Sundry Print Report

Well Name: OTTAWA AOW FED Well Location: T19S / R25E / SEC 3 / County or Parish/State: EDDY /

Notice of Intent

2781742___Ottawa_AOW_Fed_2__COA_and_Updated_Procedure_20240414121526.pdf

| eceived by OCD: 4/16/20 | ACIM | 20 P | 442 | Drono | sed P&A | | | WN-RNG: | | | | | API: 30-0 | | |

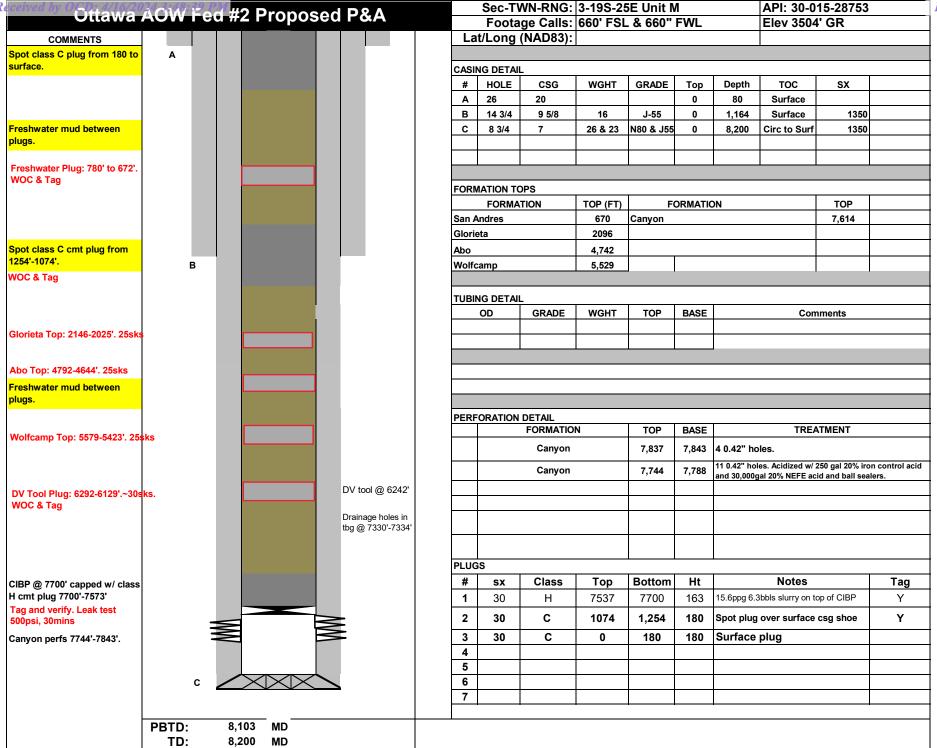
| Plug Type | Тор | Bottom | Length | Tag | Sacks | Notes |
| | | | | Verify | | |
| Surface Plug | 0.00 | 180.00 | 180.00 | circulated | | |
| Shoe Plug | 0.00 | 180.00 | 180.00 | to surface | 30.00 | |
| | | | | WOC and | | |
| Fresh Water @ 730 | 672.70 | 780.00 | 107.30 | Tag | 25.00 | |
| | | | | WOC and | | |
| Shoe Plug | 1102.36 | 1214.00 | 111.64 | Tag | 25.00 | |
| Glorieta @ 2096 | 2025.04 | 2146.00 | 120.96 | | 25.00 | |
| ABO in Plateform Shelf @ 4742 | 4644.58 | 4792.00 | 147.42 | | 25.00 | |
| Wolfcamp @ 5529 | 5423.71 | 5579.00 | 155.29 | | 25.00 | |
| | | | | WOC and | | |
| DV tool plug | 6129.58 | 6292.00 | 162.42 | Tag | 30.00 | |
| | | | | | | Existing CIBP. Leak |
| | | | | WOC and | | test casing, 500psi, |
| CIBP Plug | 7665.00 | 7700.00 | 35.00 | Tag | | 30mins |

No more than 2000' is to be allowed between plugs in open hole, and no more than 3000' between plugs in cased hole.

Class H >7500'

Class C<7500'

Fluid used to mix the cement in R111P shall be saturated with the salts common to the section penetrated, and in suitable proportions, but not more than 3% calcium chloride by weight of cement will be considered the desired mixture whenever possible.

Critical, High Cave Karst: Cave Karst depth to surface

R111P: Solid plug in all annuli - 50' from bottom of salt to surface.

Class C: 1.32 ft^3/sx Class H: 1.06 ft^3/sx

- 1. MIRU all safety equipment as needed. Kill well and remove valve. NU BOP.
- 2. Pump freshwater mud from top of plug at 7,573' to 1,254'.
- 3. Tag and verify existing CIBP and cement. Leak test casing 500psi, 30mins. Address casing leaks if any and re-test
- 4. DV Tool Plug: 6292-6129'.~30sks. WOC & Tag
- 5. Wolfcamp Top: 5579-5423'. 25sks
- 6. Abo Top: 4792-4644'. 25sks
- 7. Glorieta Top: 2146-2025'. 25sks
- 8. Spot 30 sks class C cmt plug from 1,254' to 1,074'. WOC and tag.
- 9. Freshwater Plug: 780' to 672'. 25sks. WOC & Tag
- 10. Pump freshwater mud from top of plug to 180'.
- 11. PU and spot 25 sks class C cmt plug from 180' to surface. Backfill as needed.
- 12. Cut off wellhead and verify cement is to surface on all strings. Install marker. RD and clean location as needed.
